Access Compliance Report

Public Rights-of-Way

(Curb Ramps)

Intersection ID: 8285	Main Street: CATHERINE_SIMMONS_AV	Cross Street: HAINES_ST	Location: S
ADA ID: 1554A0254F99	Ramp Type: Perp	Initial Pass/Fail: Pass	Overall Compliance: No
Codes/Mitigation Info/Possible Solution		Field Measurements/Component Compliance	
Severity Score: 15

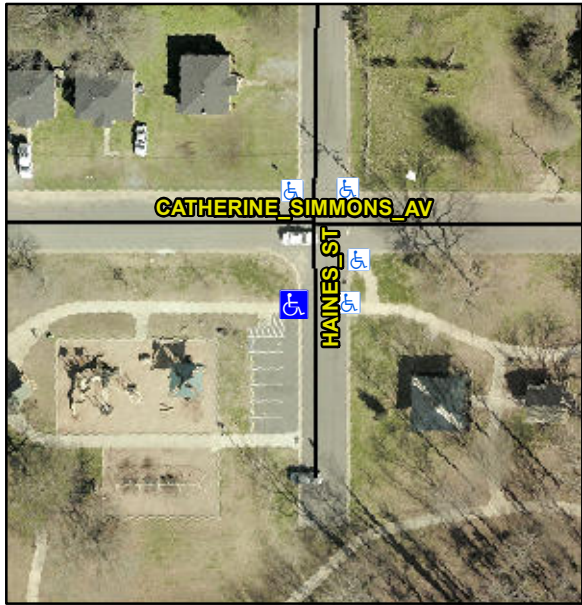
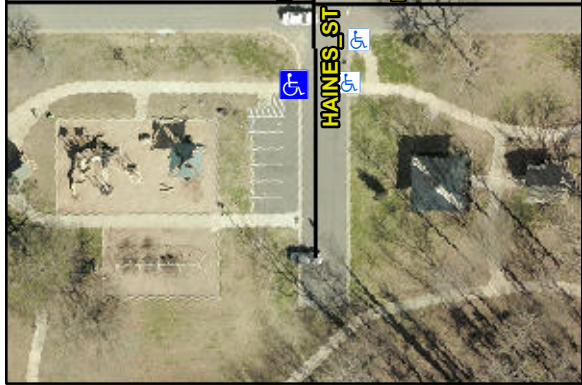
Possible Solutions:							
	Remove & Replace Entire Ramp.							
	Surveyor Notes:							
	N/A							
	PROW/ADA:							
	Not Found, R304.2.2-Perp, R304.3.2-Para, R304.5.3, R302.7.2							
	Street 1 Name	HAINES ST	Compliance	Description	Data	Compliance	Description	Data
	Stop Condition-Street 2	StopSign	N/A	Ramp Length (in)	16.5	Yes	Ramp Slope (%)	5.2
	Street 2 Name	N/A	Yes	Ramp Width (in)	48.0	Yes	Ramp XSlope (%)	2.0
	Stop Condition-Street 1	N/A	N/A	Flare Type LT	Sloped	N/A	Flare Type RT	N/A
		N/A	Flare Slope LT (%)	4.0	N/A	Flare Slope RT (%)	9.3	
		N/A	Flare Traversable LT?	Yes	N/A	Flare Traversable RT?	No	
		Yes	Landing Length (in)	80.5	Yes	DWS Provided?	Yes	
		Yes	Landing Width (in)	72.5	Yes	DWS Contrast?	Yes	
		No	Landing Slope (%)	2.1	Yes	DWS Length (in)	24.0	
		No	Landing X Slope (%)	2.8	Yes	DWS Full Width?	Yes	
		N/A	Landing Curb? (Y/N)	No	Yes	DWS Offset (in)	0.0	
		N/A	Shared Landing?	No				
		Yes	Gutter Ponding?	No	Yes	Gutter Slope (%)	1.2

No	Gutter Lip Ht (in)	2.0	Yes	Gutter X Slope (%)	0.6	
		N/A	Painted X Walk1?	No	N/A	Painted X Walk2?	N/A	
			X Walk 1 Direction	To E		X Walk 2 Direction	N/A	
		N/A	X Walk 1 Width (in)	N/A	N/A	X Walk 2 Width (in)	N/A	
			X Walk 1 Slope (%)	2.4		X Walk 2 Slope (%)	N/A	
			X Walk 1 X Slope (%)	1.5		X Walk 2 X Slope (%)	N/A	
		N/A	Ramp inside XWalk1?	N/A	N/A	Ramp inside XWalk2?	N/A	
			Road Slope (%)	N/A	N/A	Clear Space?	Yes	
			Road X Slope (%)	N/A	N/A	Clear Space to XWalk (in)	N/A	
		Yes	Any Obstructions?	No	Yes	Storm Grate/Utility Hazard?	No	
			Obstruction Type			Storm Grate/Utility Type		
					N/A		N/A	
					Yes	Surface Condition? (G/P)	Good	
Total Cost:		\$	1850.00
